CALIFORNIA COASTAL COMMISSION

STAFF REPORT: REGULAR CALENDAR

Consistency Determination No.:	CD-0001-21
Federal Agency:	Federal Highway Administration (FHWA)
Location:	From Wilder Ranch State Park north to Davenport in unincorporated Santa Cruz County (Exhibit 1)
Project Description:	A 7.5-mile multi-use bicycle and pedestrian trail that would extend along the RTC-owned railroad corridor
Staff Recommendation:	Conditional Concurrence

Figure 4: Trail re-alignment alternatives. The proposed trail is in red. Photo: FHWA.

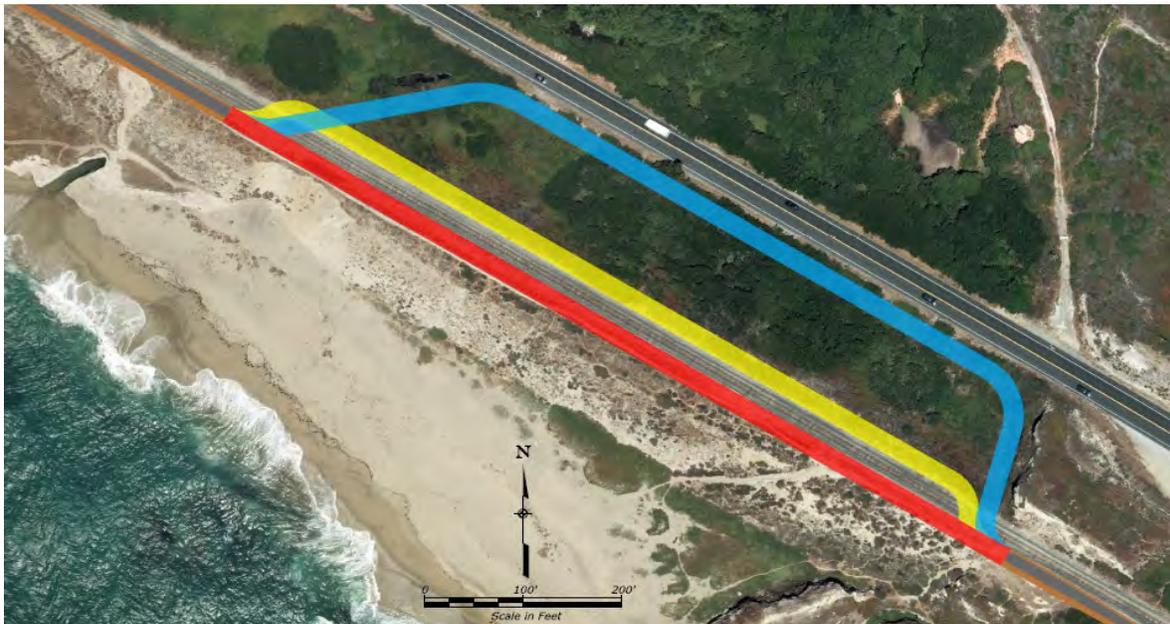
Trail re-alignment: As part of the trail design process, FHWA considered two realignment options: one on the inland side of the rail and one adjoining the highway, seen in **Figure 4** below. While technically feasible, the realignment of the trail raises several challenges.

FHWA has also stated that both realignment alternatives would require two new rail crossings, which could create a safety hazard if the rail becomes operational in the future. Introducing two new railroad crossings near the slope failure could potentially conflict with future rail services due to safety requirements for rail crossings, which are subject to approval of the California Public Utilities Commission. Alternatively, the nearest approved crossings to the north and south are located .25 miles (north) and 1.0 mile (south) from the slope failure location. To provide an inland trail alignment for 1.25 miles between these crossings also requires private property acquisition, and demolition of an existing building, which would increase environmental impacts to coastal shrub, and reduce coastal views and ocean vistas by locating the trail farther from the coast and below the grade of surrounding coastal bluffs.

The second realignment alternative would be to relocate the trail further down into the San Vicente Creek valley, adjacent to Highway 1. Although this would not require a significant structure along the embankment, FHWA states that it could also result in increased environmental impacts to habitat and have the same challenges with the added railroad crossings. In addition, it would move the public further from the coast and create steep grade changes that are undesirable for the public. Currently, although it is difficult to see in **Figure 4**, the topography of the land between the highway and the trail is an uneven elevation, so there is not a clear view of the coast from the highway, denying the public the aesthetic benefits afforded by the trail. Additionally, under the current administrative structure of the project and funding, FHWA and RTC can only develop along the immediately adjoining shoulders of the rail, and thus moving the trail inland and separating it from the rail is not presently feasible. FHWA and RTC did not pursue a realignment option that would extend the trail directly from the proposed

As discussed above, the two re-alignment options and the bridge option pose significant challenges but have the potential to greatly reduce current and future coastal resource impacts. FHWA has not provided enough project detail and information on potential impacts to definitively conclude that these options are not feasible. For example, Commission staff requested, but was not provided with, estimates on the scope and scale of potential impacts to sensitive habitats associated with the two realignment options. For the bridge alternative, FHWA provided only a concept idea, which did not allow for a serious consideration of potential impacts nor a consistency analysis.
